# JABIRU AIRCRAFT PTY LTD

## SERVICE BULLETIN: JSB 012-9

Issue: 9

Subject: Jabiru Engine Flywheel Attachment

Figure 2 - Plain washers compared to Nordloc washers (flywheel with steel centre).

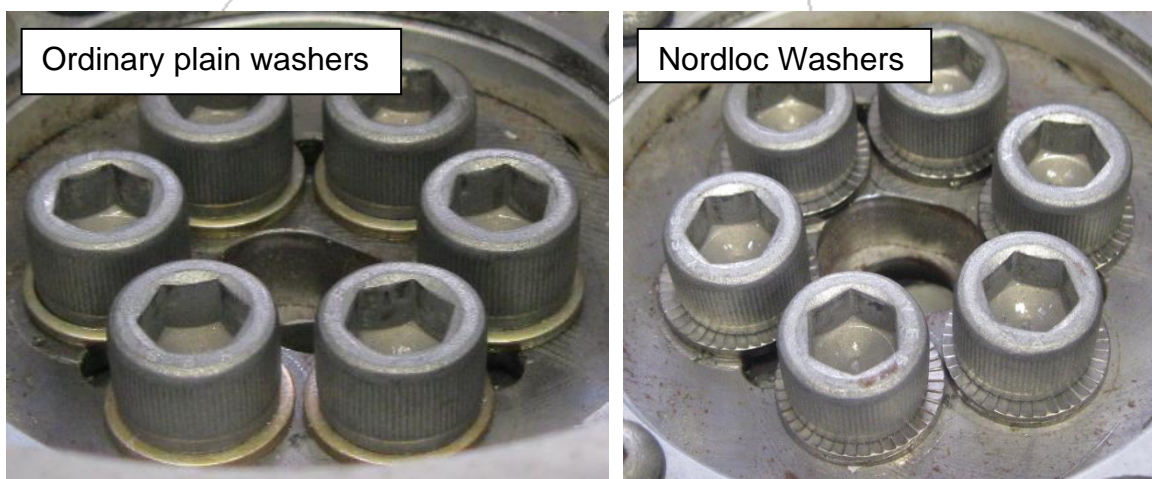
This service bulletin also acts to inform maintainers and operators of a design change to the flywheel connection which **must** be implemented on existing engines whenever flywheel bolts are replaced (i.e. at the intervals specified in JEM0002 or at overhaul).

Flywheel screws must now be installed using Nordloc washers (replacing the previous installation which used either plain or Belleville washers). Jabiru engines of any and all flywheel configurations (as defined in Table 1) should now use Nordloc washers. These washers are easily identified via visual inspection as shown below in Figure 2.

Refer to the Legacy Jabiru Engine overhaul manual JEM0001 and the Gen 4 Jabiru Engine overhaul manual JEM0002 (always check for the latest revision) for the installation procedure of flywheel capscrews using Nordloc washers. The major difference in installation is that bolts installed with Nordloc washers **must not be installed with Loctite**. The torque setting is also different for capscrews installed with these washers.

When Nordloc washers are used on an aluminium surface a steel plate must be used to protect the aluminium surface. These are available from Jabiru.

Figure 3: Flywheel with Aluminium centre and steel wear plate.

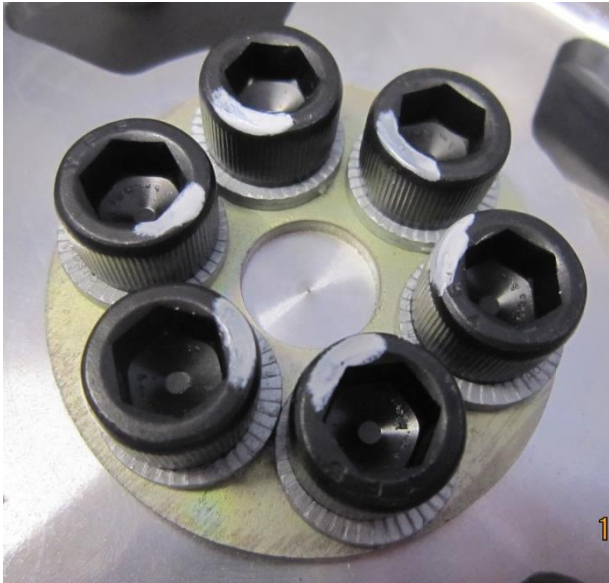
- vii) Install the Steel wear plate. Note: if you have a flywheel with a steel centre “Starfish” a steel wear plate is not required.
- viii) Install new Cap screws with Nordloc washers and torque up as described in the Overhaul manual JEM0001 (check for latest issue). Note that only new “Unbrako” or “Brighton Best 1960-Series” screws are to be used.
